<b>BW Project No.:</b>	24-12-247
<b>BW Project Title:</b>	DPW. 25269 UI Campus Drive Repairs, Phase 3
<b>Client:</b>	University of Idaho
<b>Date:</b>	04-23-2026
<b>Addendum #:</b>	002

This addendum consists of a total of 4 pages and 16 drawings.

# UI: CAMPUS DRIVE REPAIRS, PHASE 3 UNIVERSITY OF IDAHO

**ELECTRICAL  
 PLAN  
 E1.0**

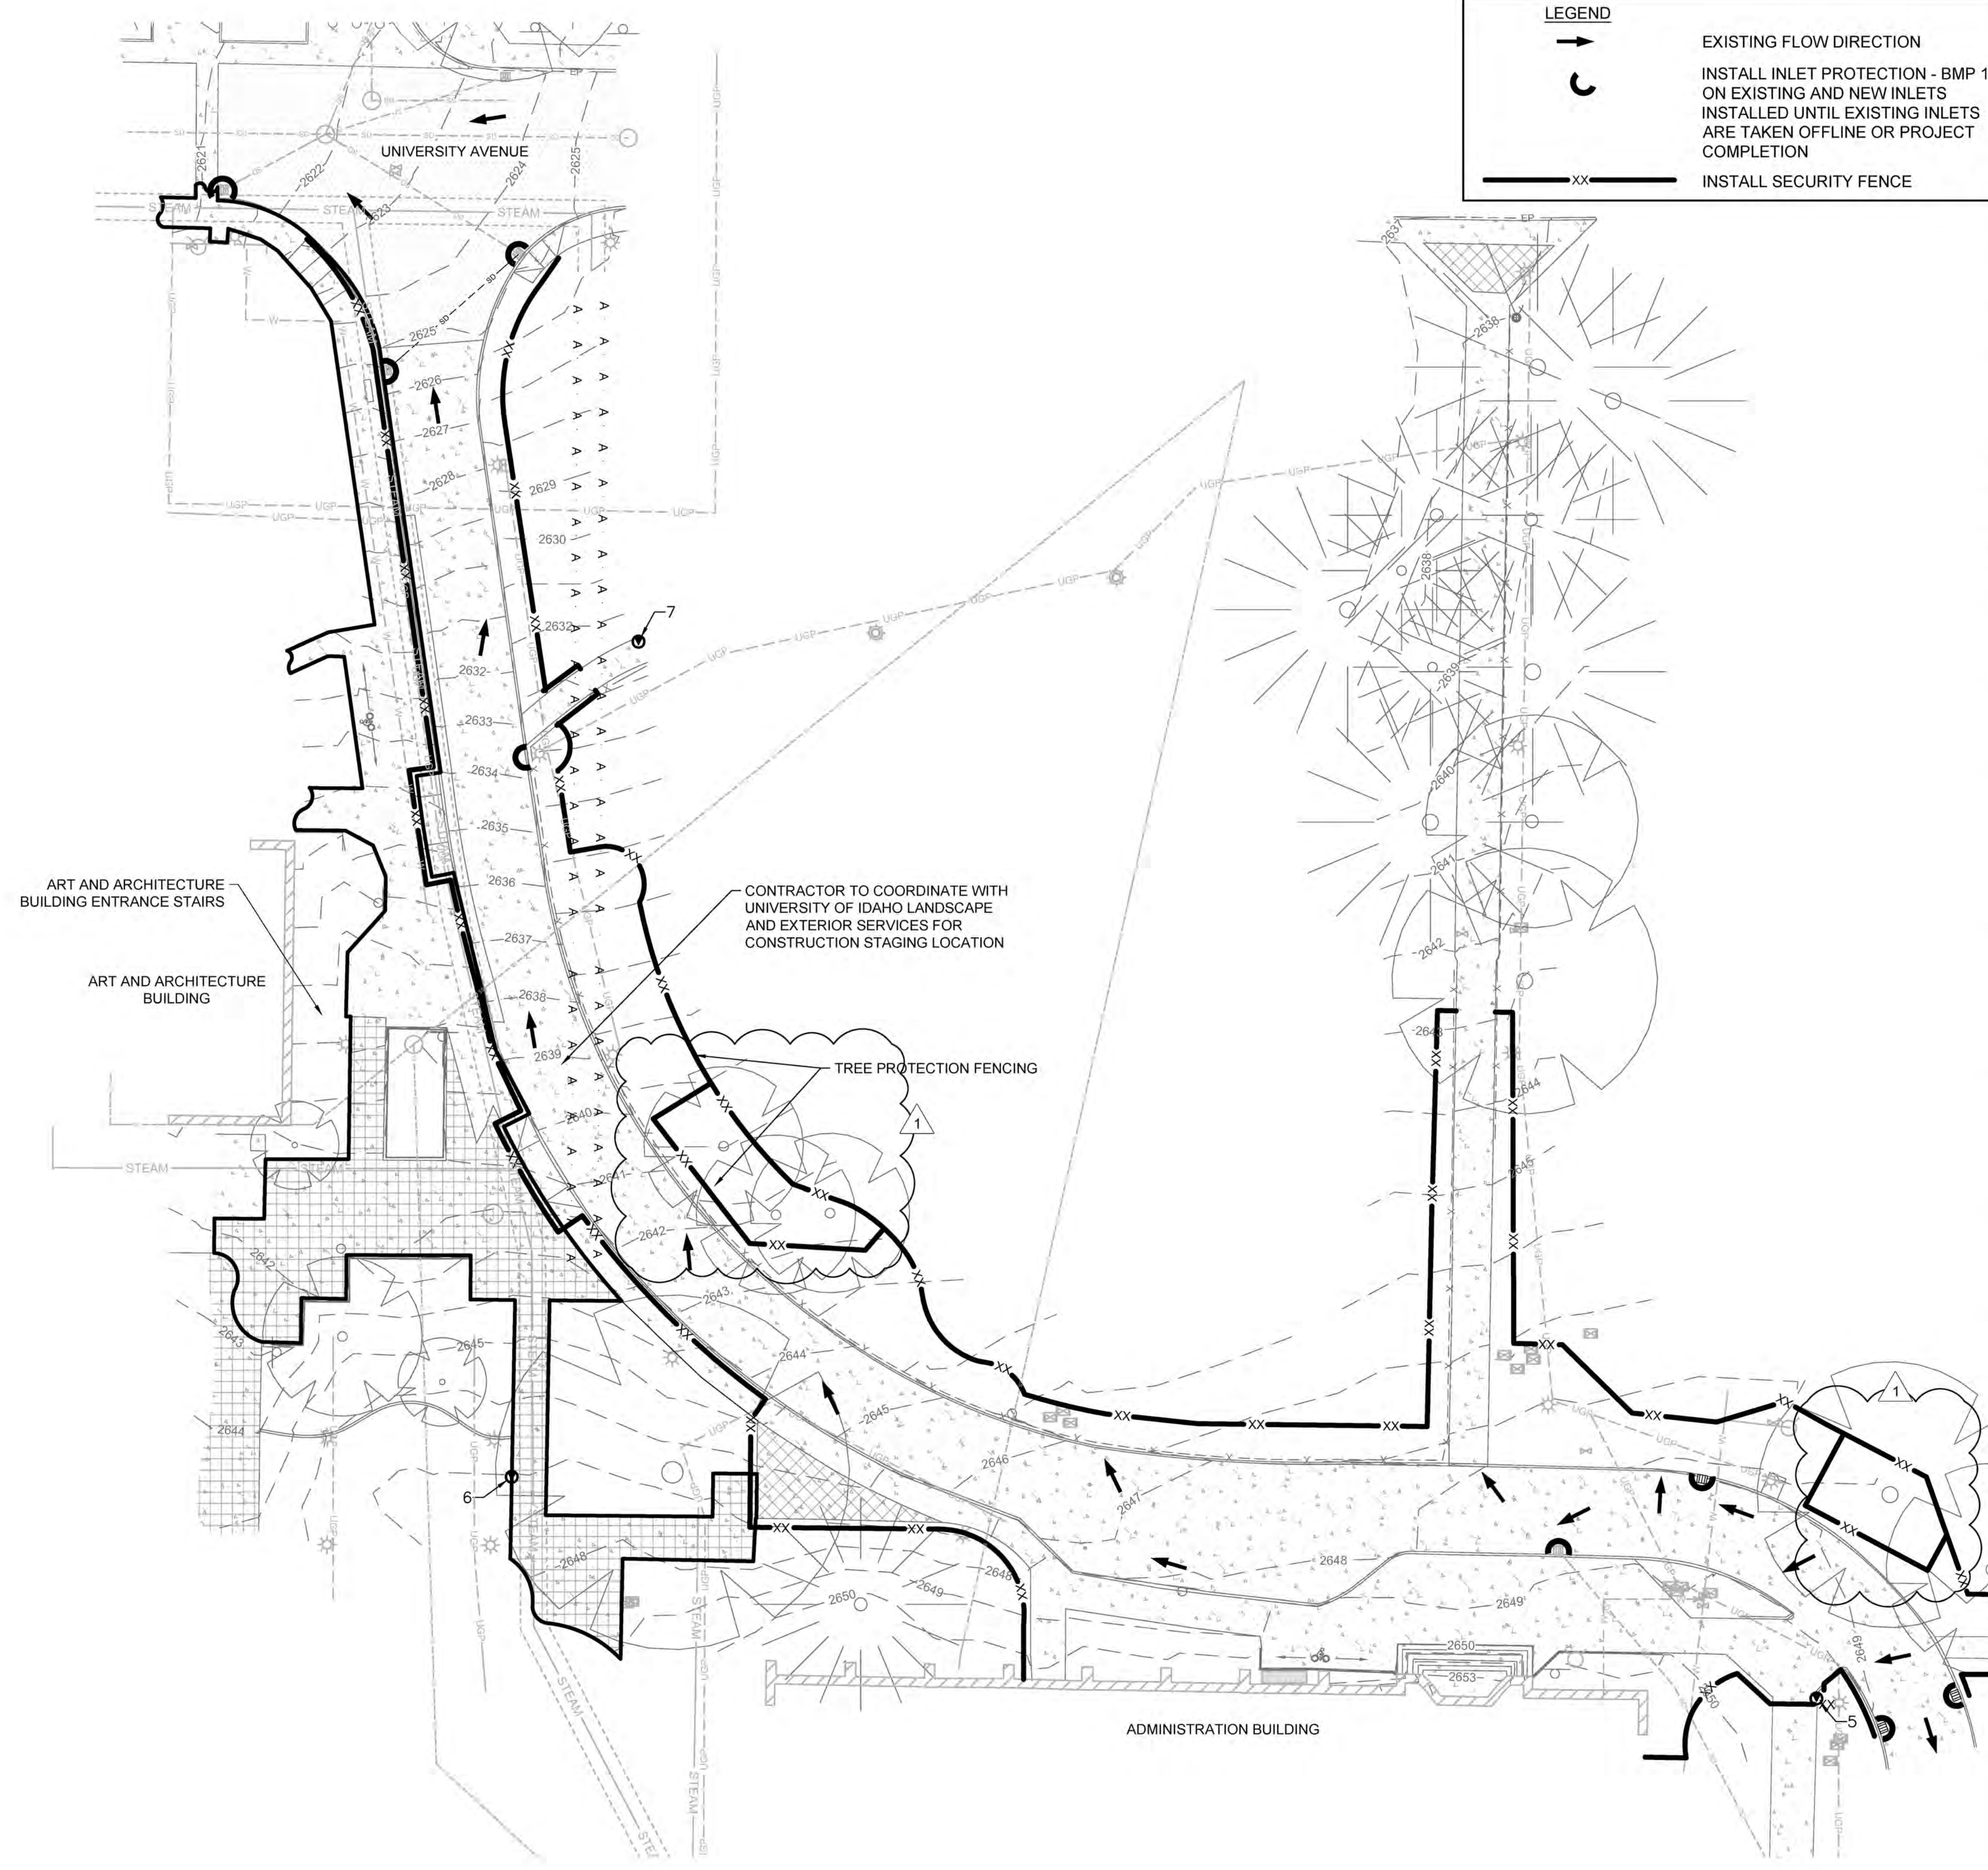
15. Sheet E1.0: was revised to move one light location and show the schematic location of the electrical conduit away from tree roots and drip line as much as possible.

DEMOLITION  
PLAN

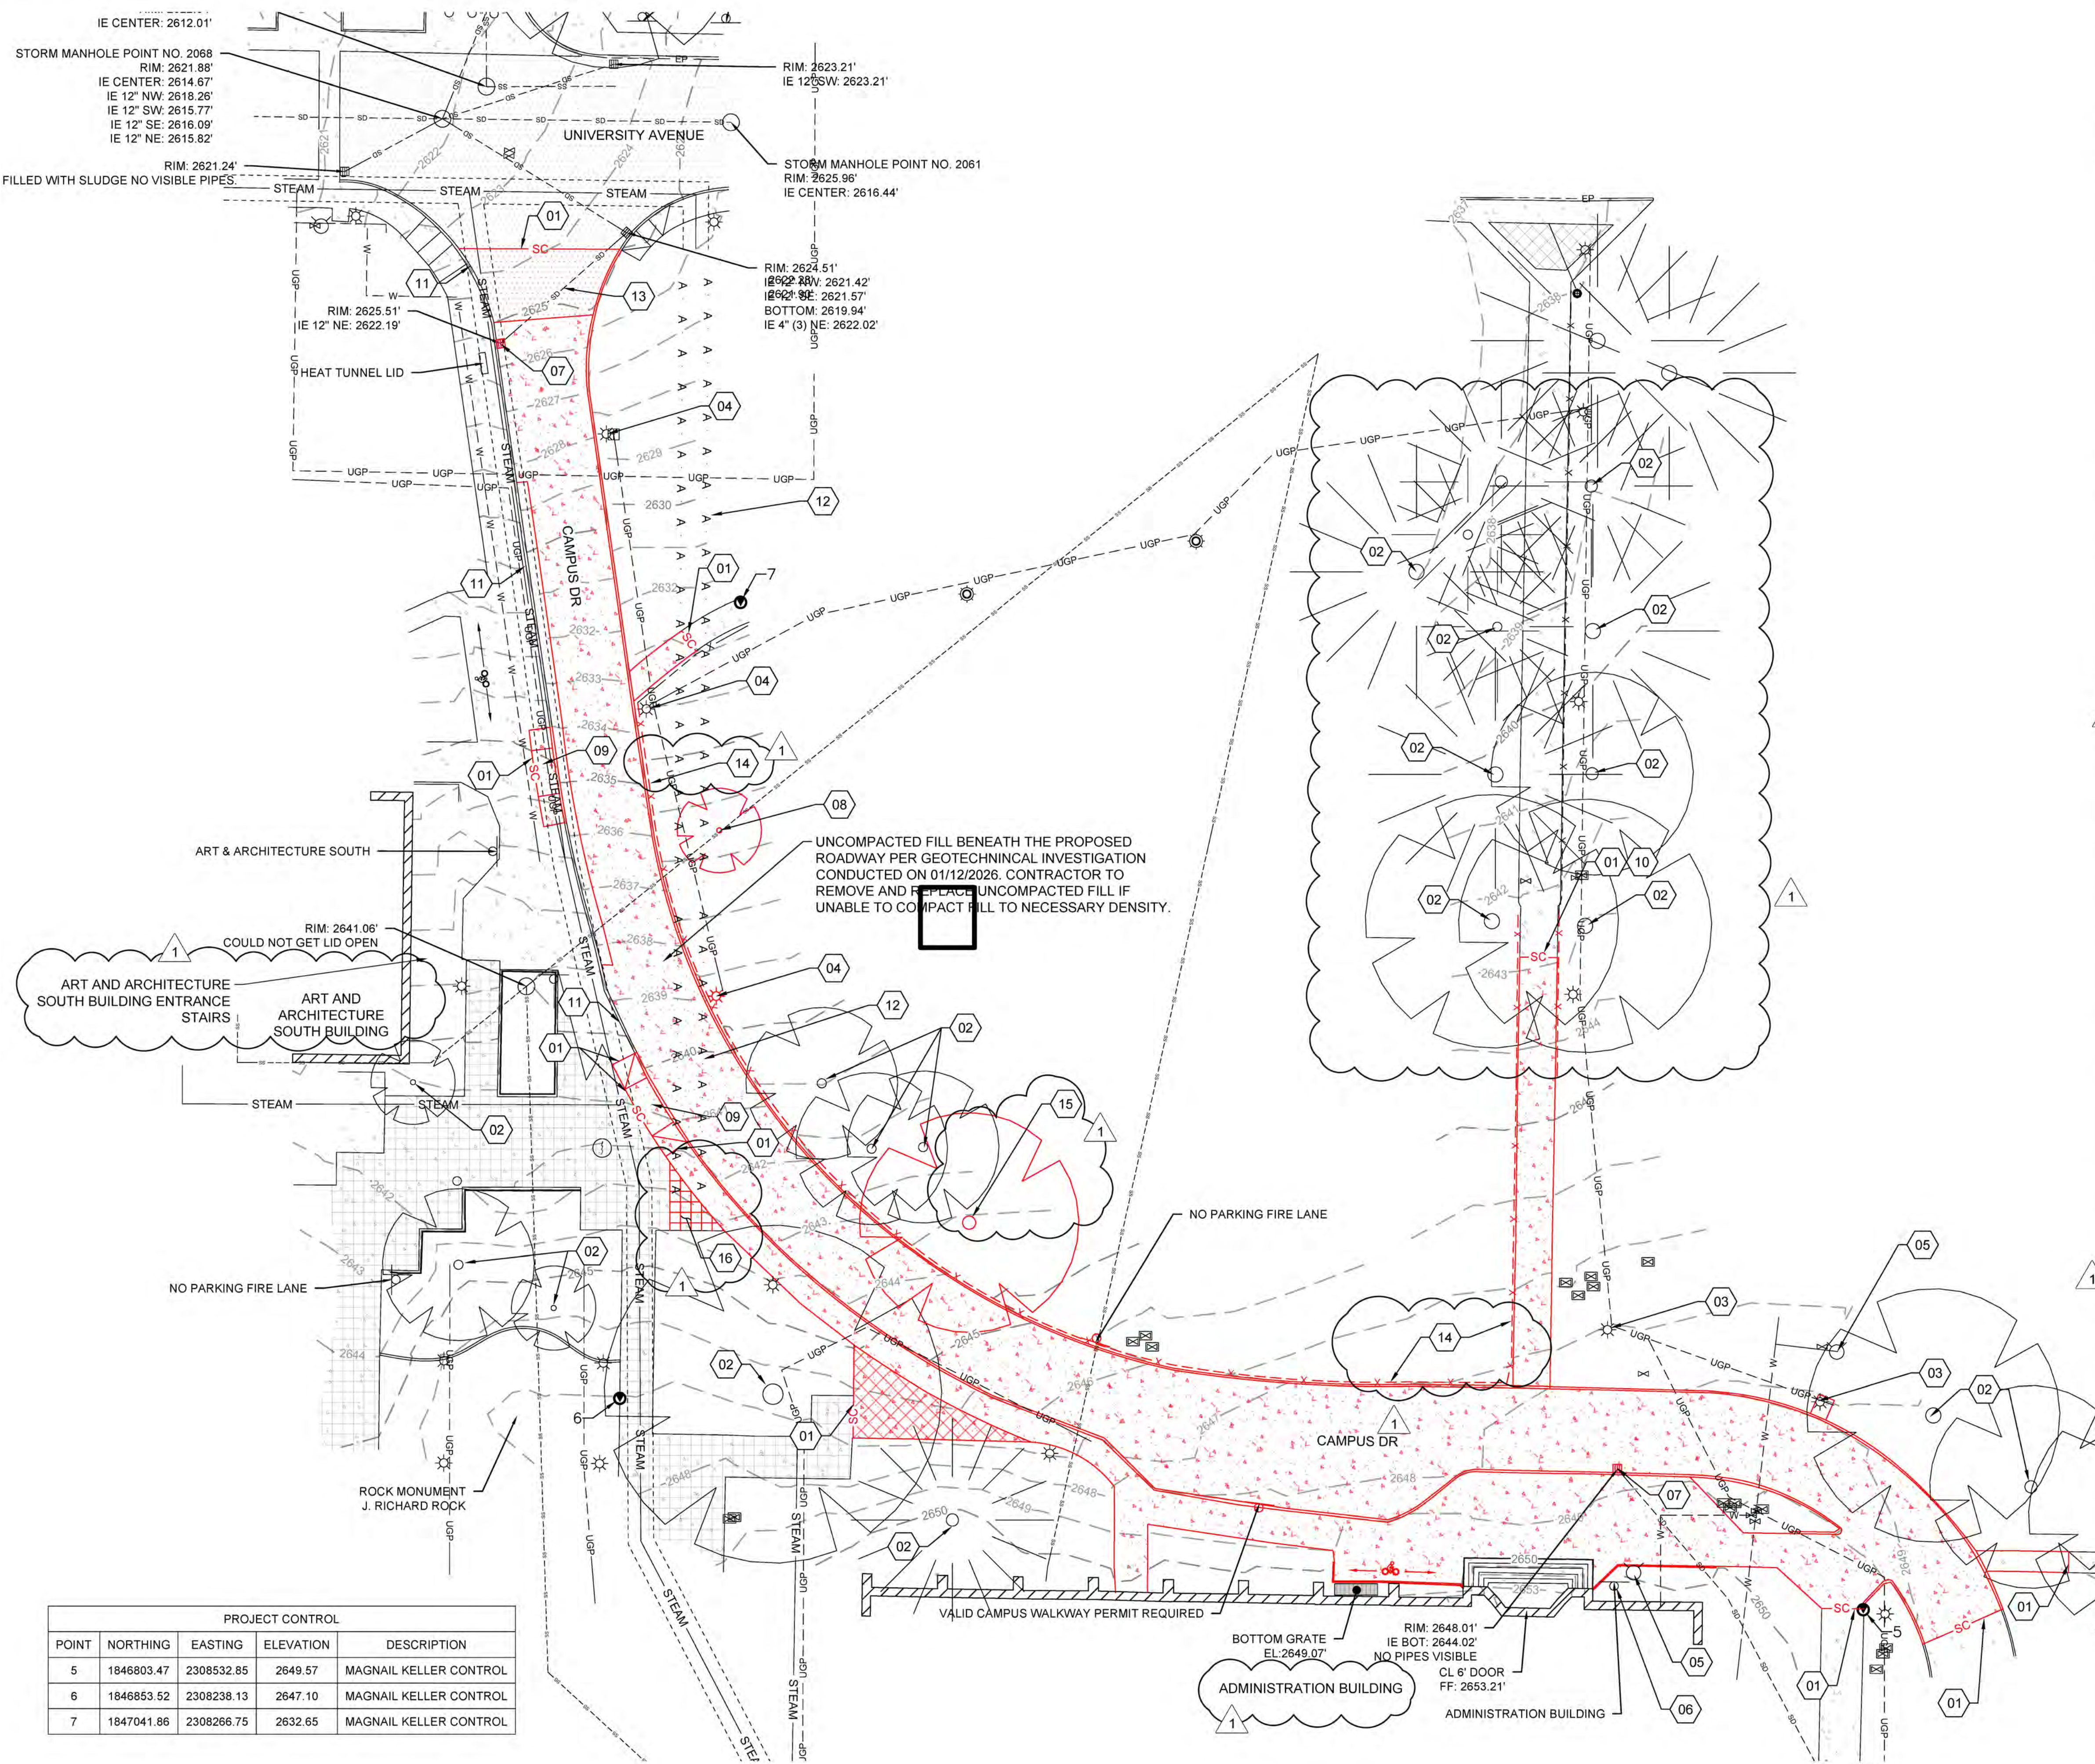
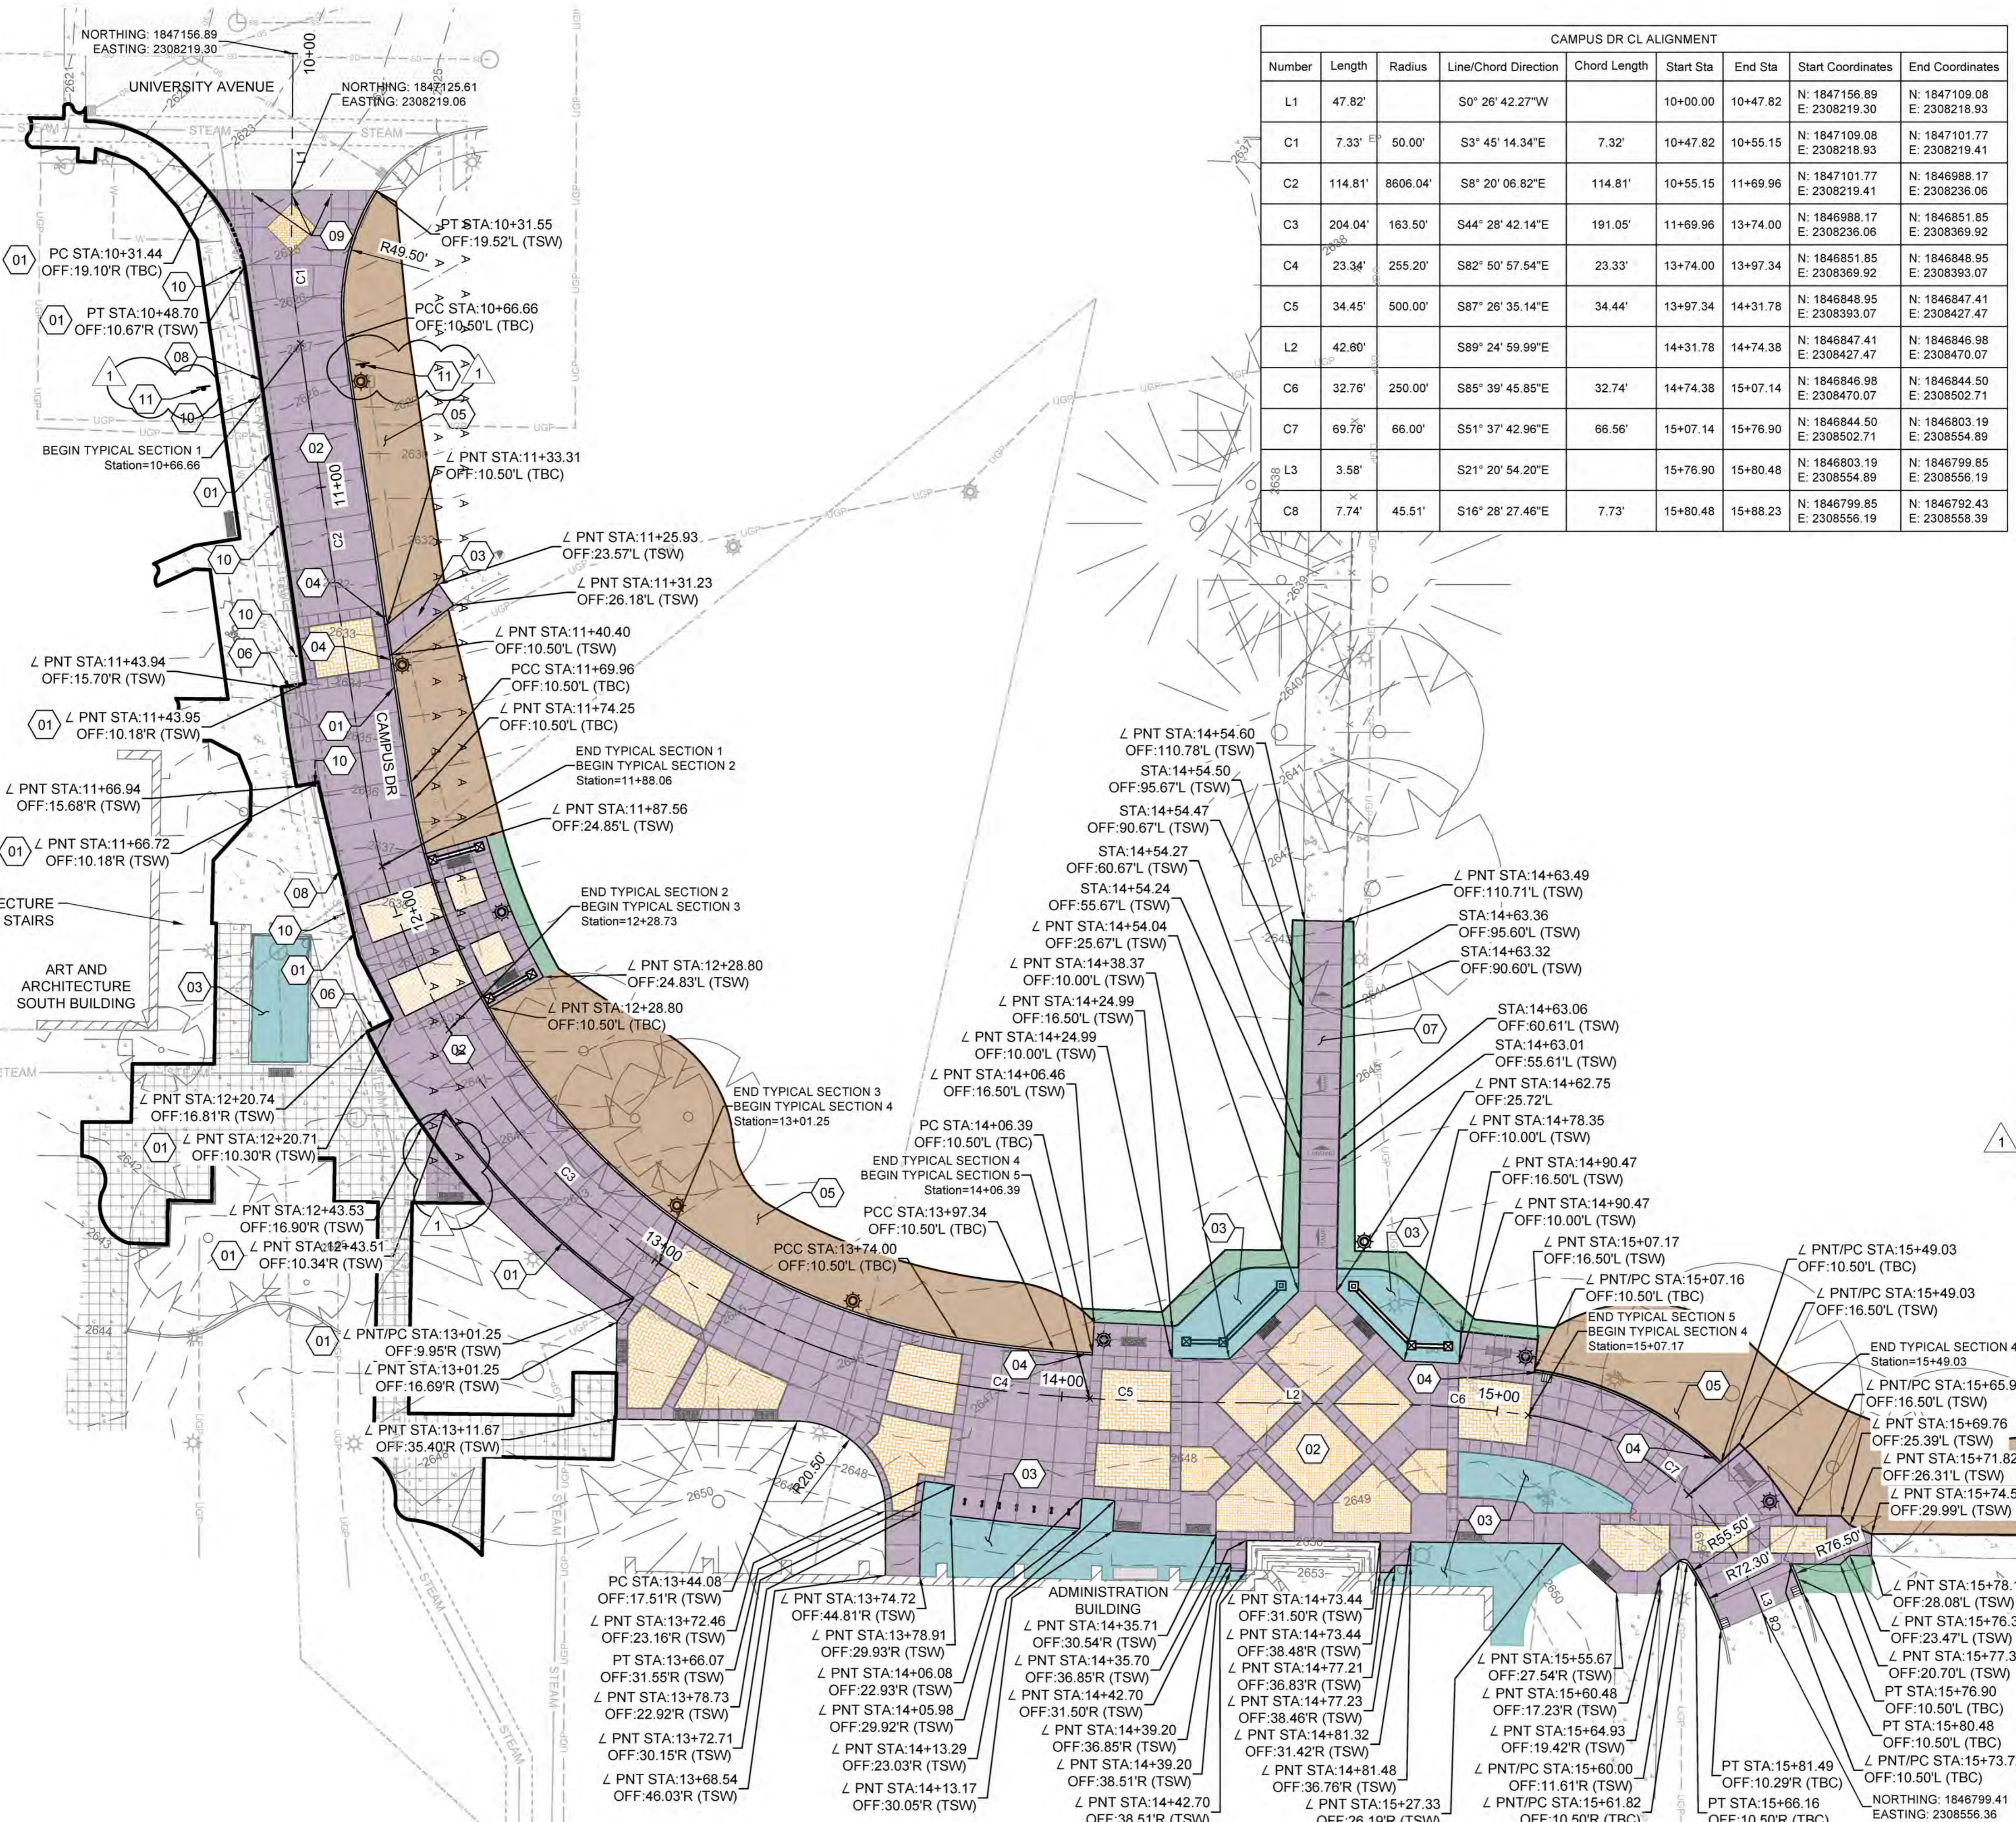
11. Sheet C1.1: Demo sheet has been updated to include additional concrete removal where tunnel removed. Also removed language regarding painting wester curb red for fire lane. Handrail demo line was added. Added note for tree root removal.
